Office Action Summary	Application No. 10/537,008	Applicant(s) VENKITASUBRAHMANIAN ET AL.	
	Examiner Tung X. Le	Art Unit 2821

DETAILED ACTION

FIG. 6

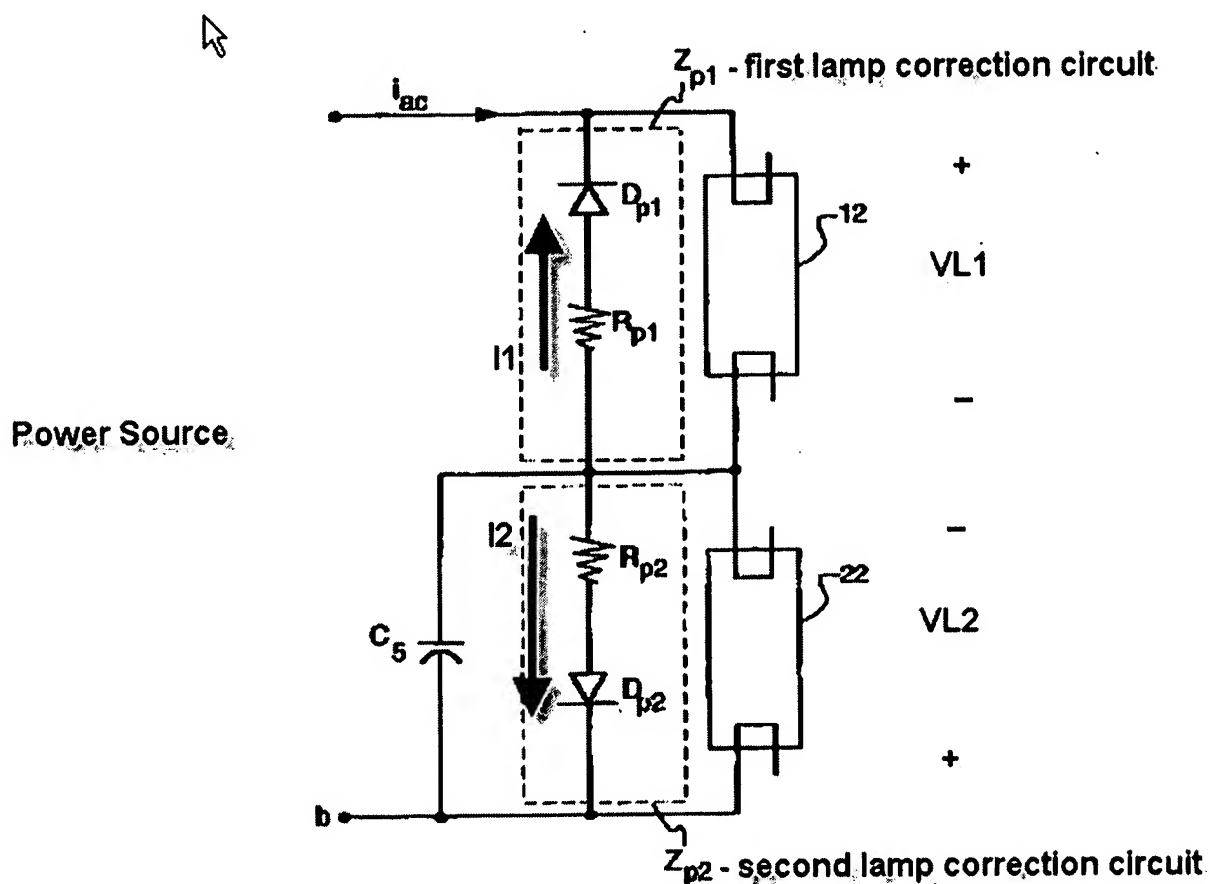
With respect to claim 5, Steigerwald discloses in figure 6 that the striation correction circuit comprises a first lamp correction circuit (Zp1) for generating the first striation correction current in the first fluorescent lamp (12) and a second lamp

correction circuit (Z_{p2}) for generating the second striation correction current in the second fluorescent lamp (22).

With respect to claim 6, Steigerwald discloses that the first lamp correction circuit is arranged in parallel with the first lamp (figure 6) and the second lamp correction circuit is arranged in parallel with the second lamp (figure 6) and wherein the first and second lamp circuits are in series (figure 6).

With respect to claim 7, Steigerwald discloses that the first lamp correction circuit (Zp1) and the second lamp correction circuit (Zp2) each comprise a diode (Dp1 and Dp2) in series with a resistor (Rp1 and Rp2) and wherein the first and second lamp correction circuits are arranged symmetrically with the diodes opposing one another (figure 6).

With respect to claim 8, Steigerwald discloses in figure 6 that the first lamp correction circuit and the second lamp correction circuit comprises at least one transistor (having the two diodes [Dp1 and Dp2] functioning as semiconductor transistors).

With respect to claim 15, Steigerwald discloses in figure 6 that a striation circuit (Zp1 and Zp2) comprises a first lamp correction circuit (Zp1) for generating the first striation correction current (I1) in the first fluorescent lamp (12) and a second lamp correction circuit (Zp2) for generating the second striation correction current (I2) in the second fluorescent lamp (22).

With respect to claim 16, Steigerwald discloses that the first lamp correction circuit is arranged in parallel with the first lamp (figure 6) and the second lamp correction circuit is arranged in parallel with the second lamp (figure 6) and wherein the first and second lamp correction circuits are in series (figure 6).

With respect to claim 17, Steigerwald discloses in figure 6 that the first lamp correction circuit and the second lamp correction circuit each comprises a diode (Dp1 and Dp2) in series with a resistor (Rp1 and Rp2) and wherein the first and second lamp correction circuits are arranged symmetrically with the diodes opposing one another (figure 6 shows the diodes [Dp1 and Dp2] opposed direction to each other).

With respect to claim 18, Steigerwald discloses in figure 6 that the first lamp correction circuit and the second lamp correction circuit are comprised of at least one component selected from the group consisting of a diode (Dp1 and Dp2).
